Origination Form Proposed Revisions to a Standard Plans Index

Originator:	Turley, Joshua	Index Number:	521-611
Date:	6/5/2024	Sheet Number(s):	1
E-mail:	Joshua.Turley@dot.state.fl.us	Index Title:	CONCRETE BARRIER/JUNCTION SLAB - WALL COPING (FRP)

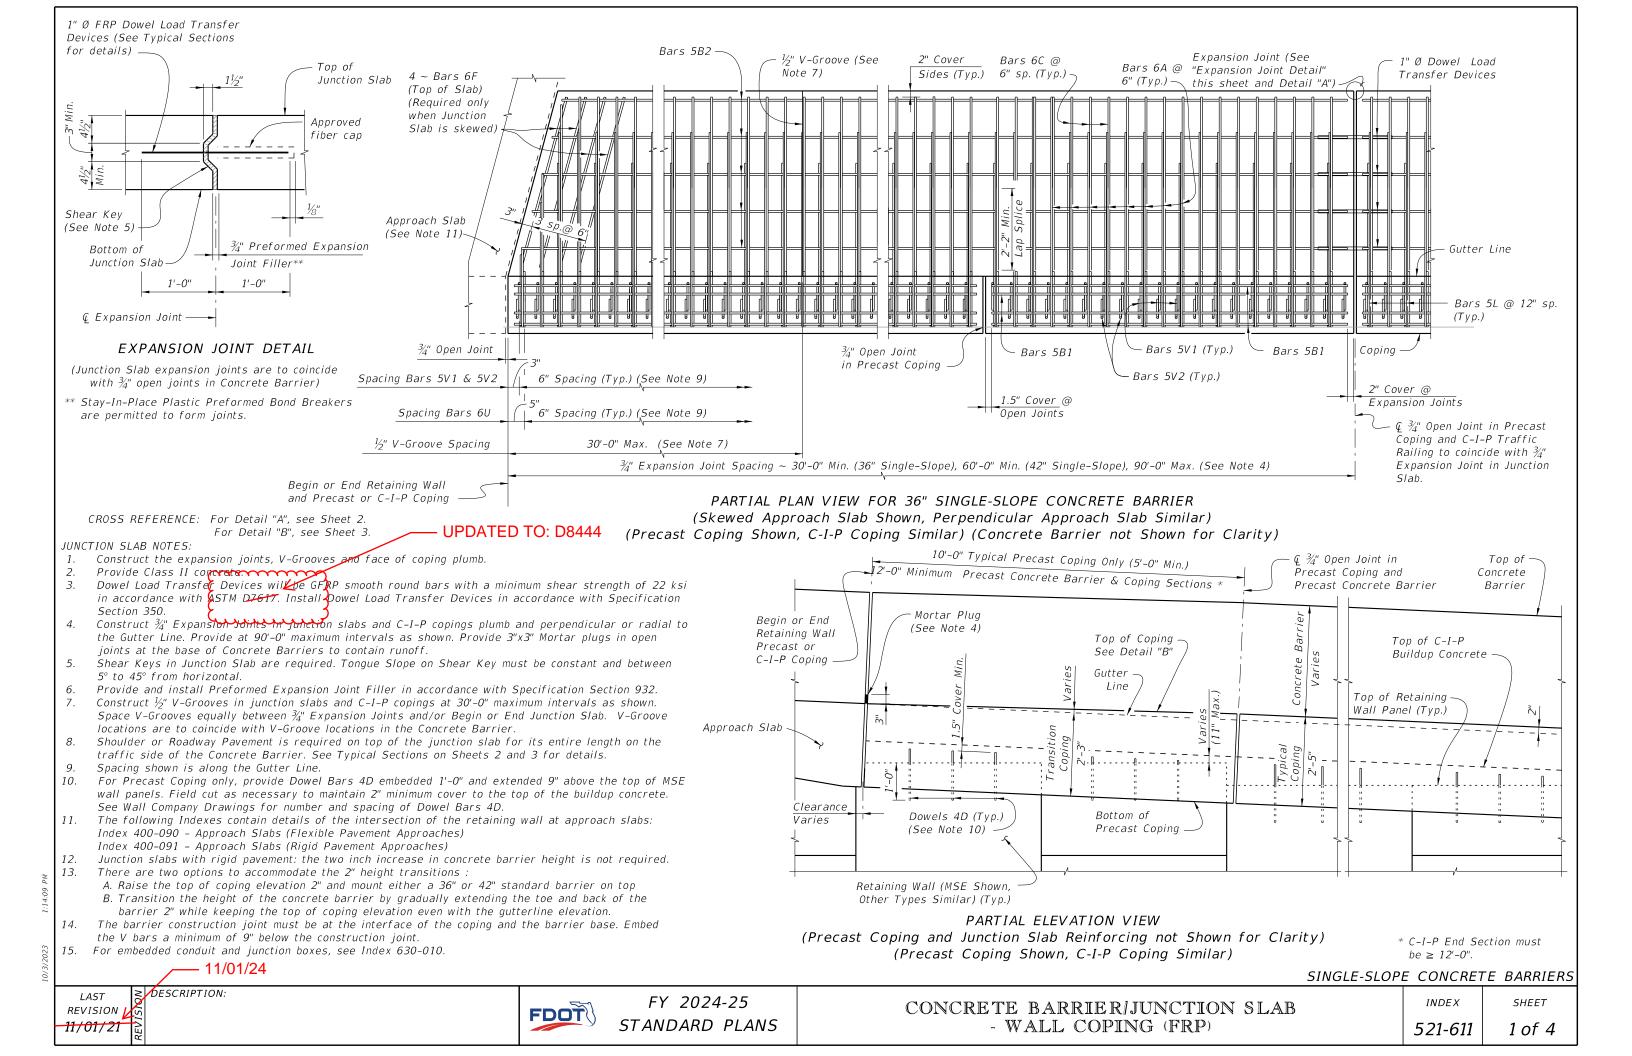
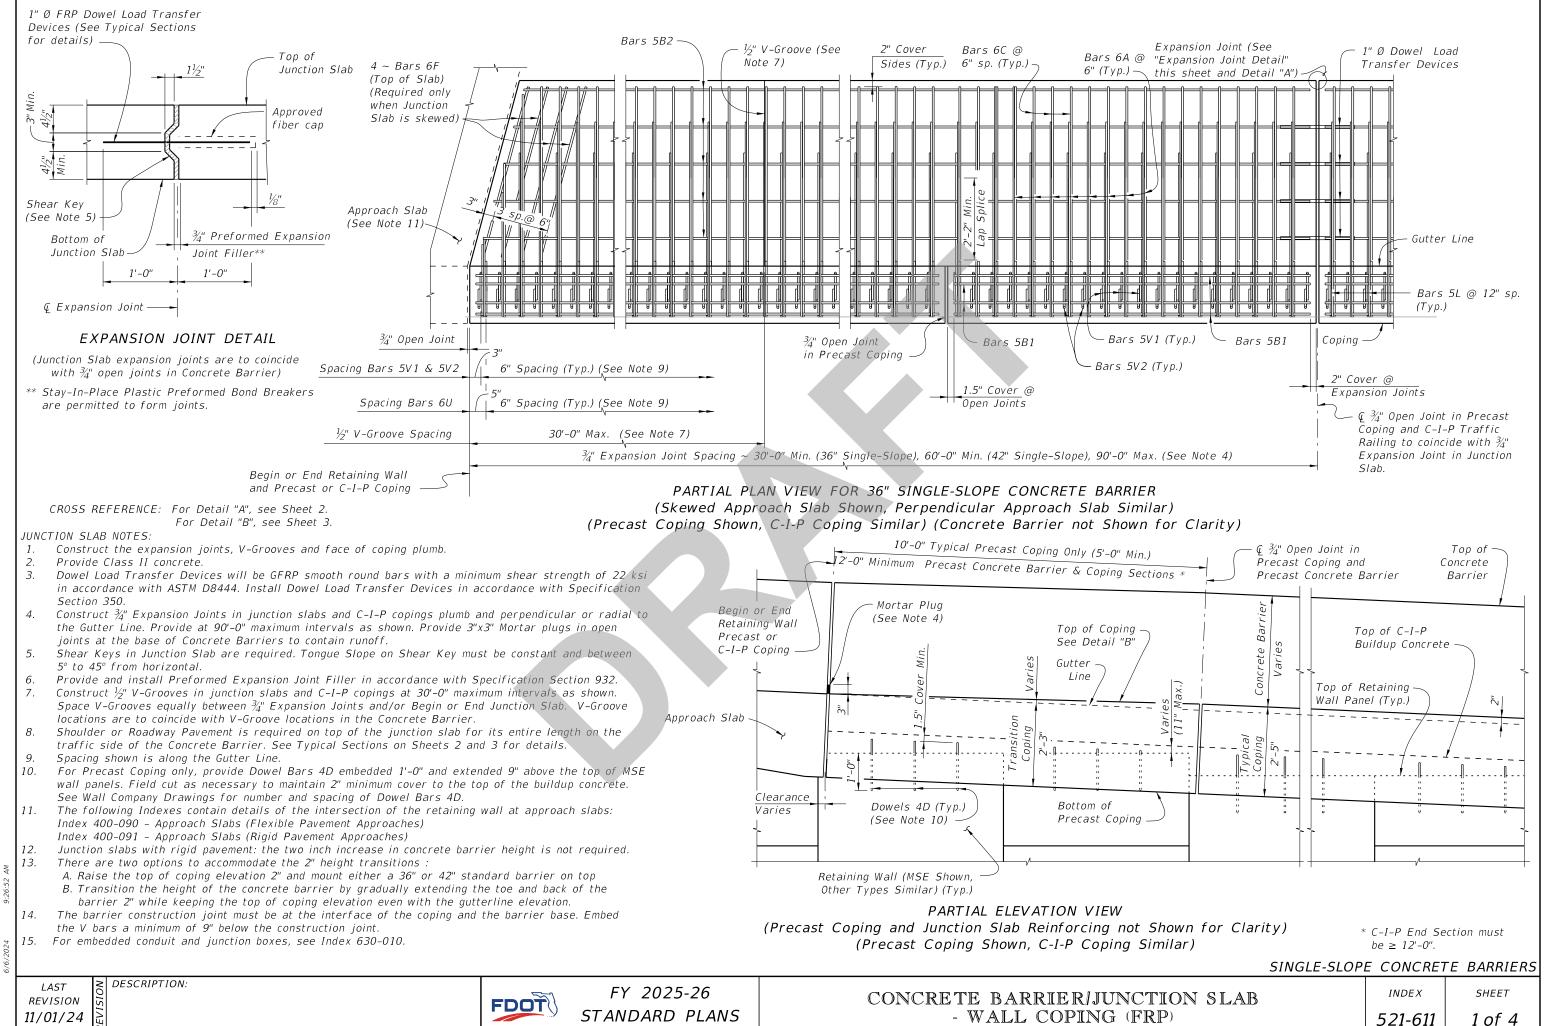
Sheet 1: Updated ASTM reference for GFRP dowel load transfer devices

There is a updated more comprehensive ASTM that has recently been made available.
